ROSWELL ROAD SELF STORAGE

REZONING SITE PLAN

PETITION NO: Z-22

ZONING COMMENTS:

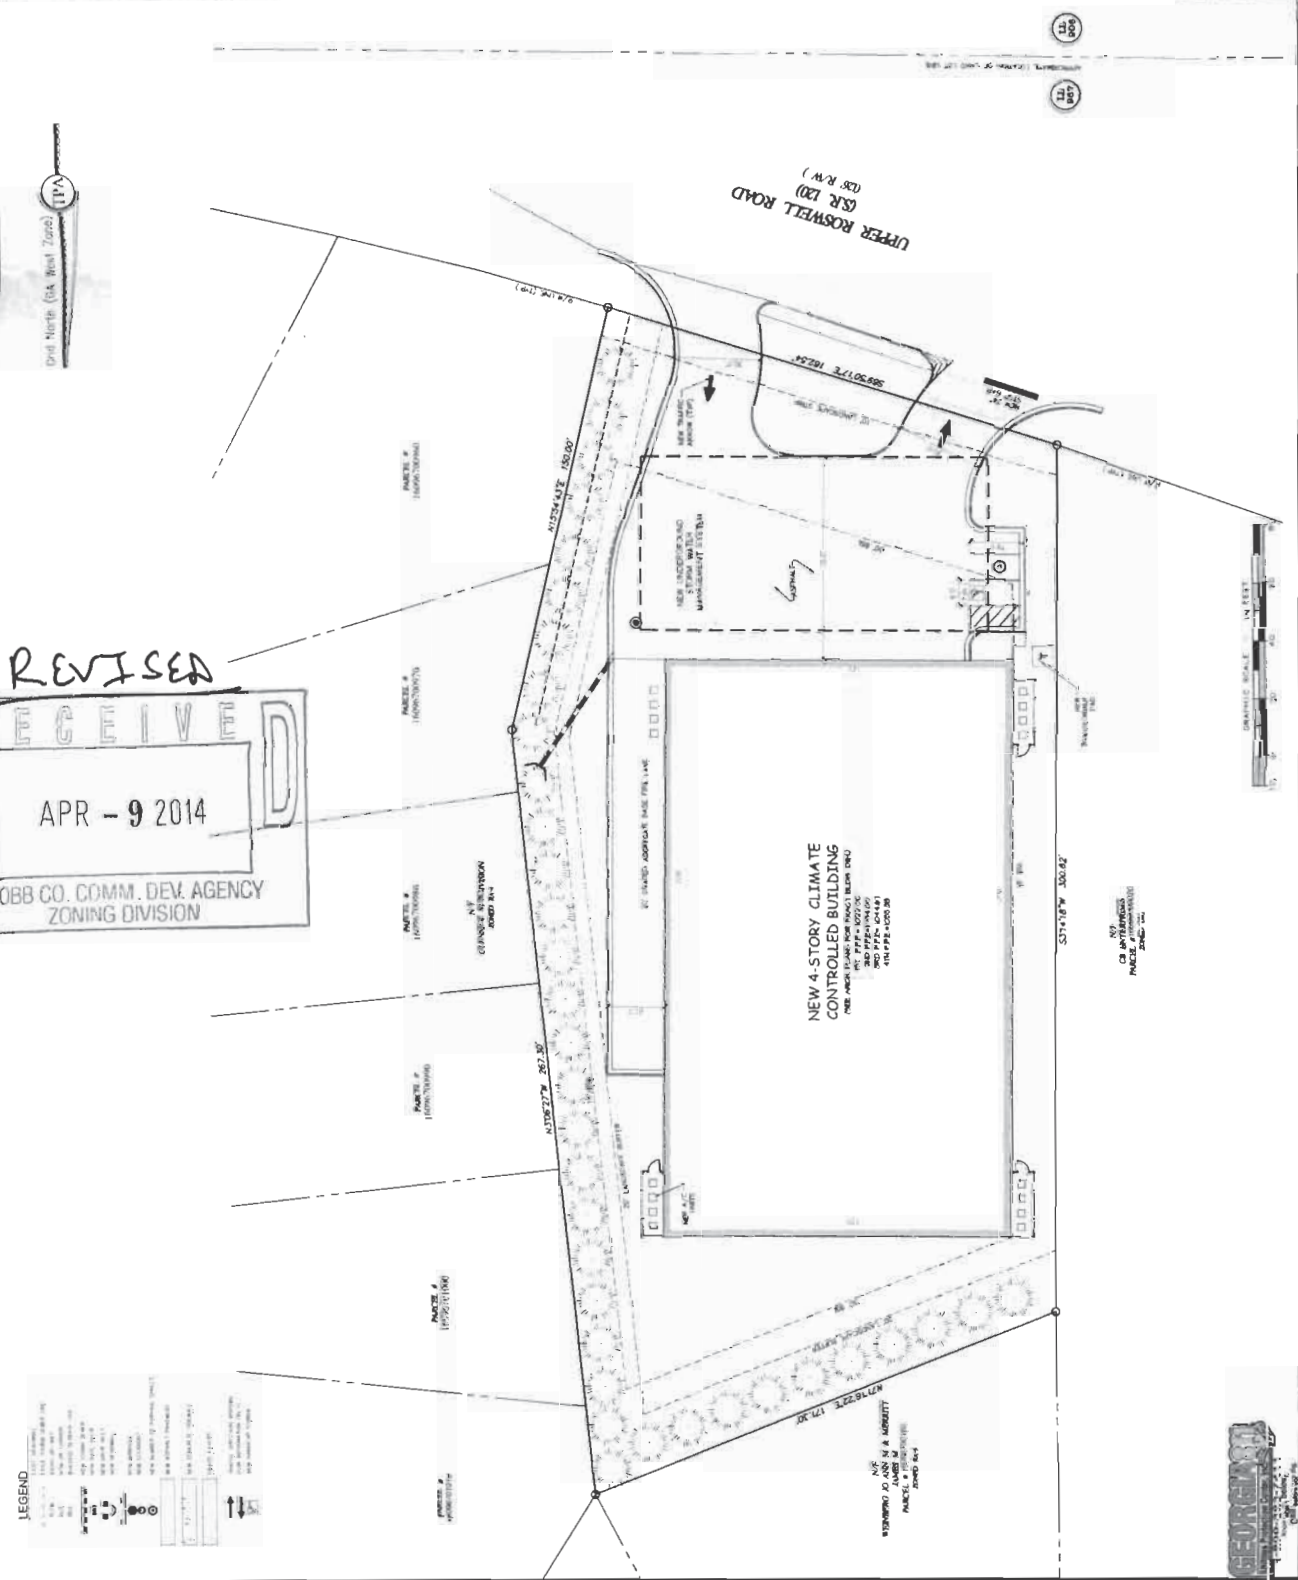
The proposed building height of 51'8" is much higher than those residences immediately located to the west of the subject site. This could be seen as contradictory to the Code's minimum standards of "(not) impact the view shed of adjacent residential property." Also, the proposed floor to area ratio (FAR) is 1.55, well over the 1.0 suggested by the Code. While all units are accessed internally, it is not clear from the applicant's submissions if all windows are "one way" as prescribed by the Code. Too, the Code requires that "architectural style/design to be similar or complementary to the predominant architectural design of other commercial uses within the activity center." The proposed architecture of the storage facility appears more modern with expanses of EIFS, glass, metal accents and modular brick veneer while nearby office uses within the activity center of this portion of Roswell Road and Robinson Road are of a more traditional style of brick construction. A minimal landscaping plan has been provided which shows a 20 foot landscape buffer adjacent to the residential properties to the south and west as well as landscaping of the frontage.

- No Stormwater controls shown _____
- Copy of survey is not current – Additional comments may be forthcoming when current site conditions are exposed.
- No site improvements showing on exhibit.

2. The proposed site plan shows the detention facility discharging to the existing drainage easement in the adjacent Glenside Subdivision to the west. The stormwater management design must evaluate and account for the existing conveyance capacity of this older system as well the volume impact on the existing subdivision detention pond. As an alternative the site could be discharged to the existing stormwater system in the Roswell Road R/W subject to the available capacity. The final discharge point must be decided in Plan Review.
